<b>Title - Sujet</b> Réfection flanc gauche - Ursulines	
<b>Solicitation No. - N° de l'invitation</b> EE520-182382/A	<b>Amendment No. - N° modif.</b> 001
<b>Client Reference No. - N° de référence du client</b> EE520-182382	<b>Date</b> 2018-02-26
<b>GETS Reference No. - N° de référence de SEAG</b> PW-\$QCL-018-17344	
<b>File No. - N° de dossier</b> QCL-7-40267 (018)	<b>CCC No./N° CCC - FMS No./N° VME</b>
<b>Solicitation Closes - L'invitation prend fin</b> <b>at - à 02:00 PM</b> <b>on - le 2018-03-14</b>	
<b>F.O.B. - F.A.B.</b> <b>Plant-Usine:</b> <input type="checkbox"/> <b>Destination:</b> <input checked="" type="checkbox"/> <b>Other-Autre:</b> <input type="checkbox"/>	
<b>Address Enquiries to: - Adresser toutes questions à:</b> Piras, Gabriel	<b>Buyer Id - Id de l'acheteur</b> qcl018
<b>Telephone No. - N° de téléphone</b> (418) 649-2870 ( )	<b>FAX No. - N° de FAX</b> (418) 648-2209
<b>Destination - of Goods, Services, and Construction:</b> <b>Destination - des biens, services et construction:</b> Bastion des Ursulines Fortifications de Québec Entre la Porte Kent et la Porte St-Louis Québec, QC

TITLE : RESTORATION OF BASTION DES URSULINES LEFT FLANK  
FORTIFICATIONS OF QUEBEC, QUE

2 - Appendix 1 - Combined Price Form, Unit Price Table, Item 2 and Lump Sum, Item 17.

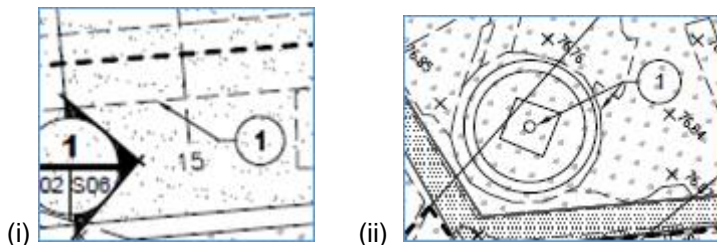
Unless I am mistaken, the supply of cord stones is in two separate items, as referenced. In which of these two items should these stones be included?

**Answer :** An addendum will be issued to correct the situation. The replacement of the belt course is a lump sum, line 17 of the slip.

Ref. : Sheet S02 – see sketch

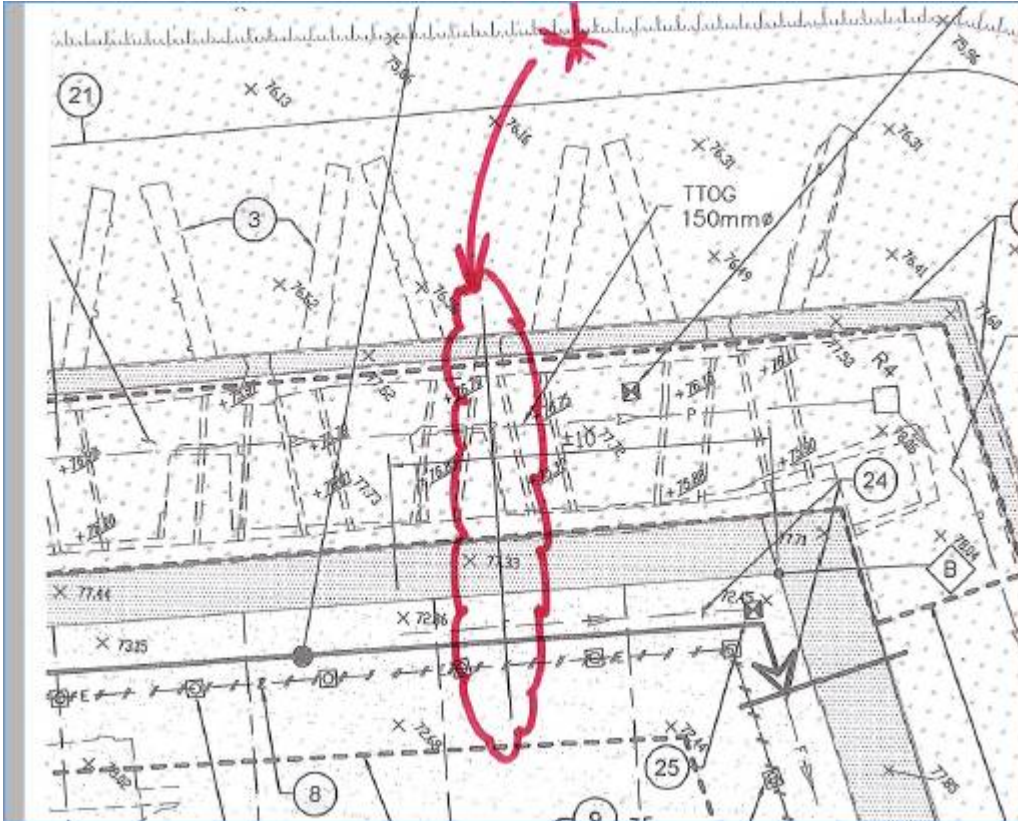
We wonder if a section was not forgotten or unidentified, as shown on the sketch.

**Answer** : This line does not have to be considered, it is a printing problem.

Ref. : Sheet S03 – References « A » and « B »

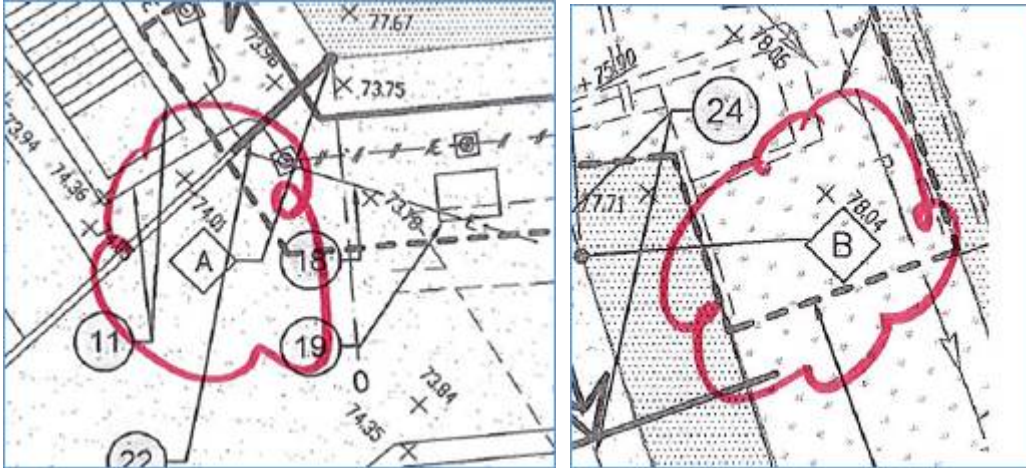
Unless we are mistaken, we seek to find the meaning of the letters cited in reference. Please comment.

**Answer :** We do not see references A and B on page S03. However, on page S02, points A and B are shown at the corners of the wall and refer to the table of coordinates of page S02.
